Access Compliance Report

Public Rights-of-Way

(Curb Ramps)

Intersection ID: 13679	Main Street: EUCLID_AV	Cross Street: LEXINGTON_AV	Location: E
ADA ID: BB525C45DE8D	Ramp Type: Directional1	Initial Pass/Fail: Fail	Overall Compliance: No
Codes/Mitigation Info/Possible Solution		Field Measurements/Component Compliance

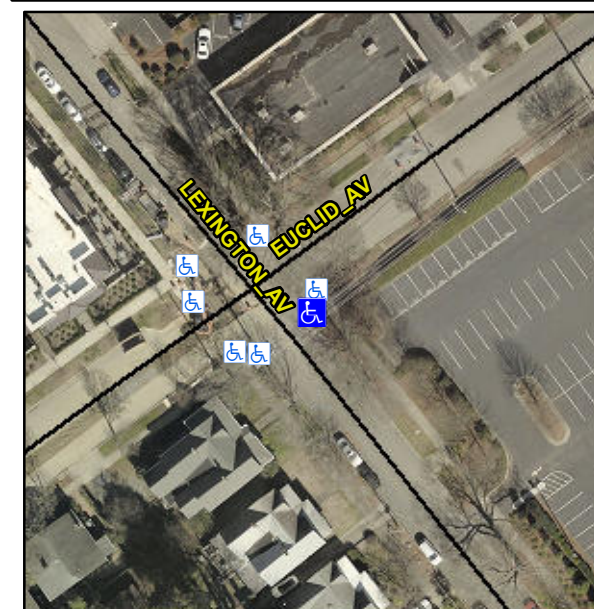
R304.2.2, R304.5.3

Compliance	Description	Data	Compliance	Description	Data
N/A	Ramp Length (in)	79.0	N/A	Grade Break?	N/A
Yes	Ramp Width (in)	48.0	N/A	Grade Break Slope (%)	0.0
No	Ramp Slope (%)	16.7	N/A	Grade Break XSlope (%)	0.0
No	Ramp XSlope (%)	2.6			
N/A	Flare Type LT	N/A	N/A	Flare Type RT	N/A
N/A	Flare Slope LT (%)	N/A	N/A	Flare Slope RT (%)	0.0
N/A	Flare Traversable LT?	N/A	N/A	Flare Traversable RT?	N/A
N/A	Landing Length (in)	0.0	N/A	DWS Provided?	N/A
N/A	Landing Width (in)	0.0	N/A	DWS Contrast?	N/A
N/A	Landing Slope (%)	0.0	N/A	DWS Length (in)	N/A
N/A	Landing X Slope (%)	0.0	N/A	DWS Full Width?	N/A
N/A	Landing Curb? (Y/N)	N/A	N/A	DWS Offset LT (in)	N/A
N/A	Shared Landing?	N/A	N/A	DWS Offset RT (in)	N/A
N/A	Gutter Ponding?	0.0	N/A	Gutter Slope (%)	N/A
N/A	Gutter Lip Ht (in)	0.0	N/A	Gutter X Slope (%)	N/A
N/A	Painted X Walk1?	No		Road Slope (%)	2.7
	X Walk 1 Direction	To SW		Road X Slope (%)	4.7
	X Walk 1 Width (in)	N/A		Clear Space?	N/A

Remove & Replace Entire Ramp.
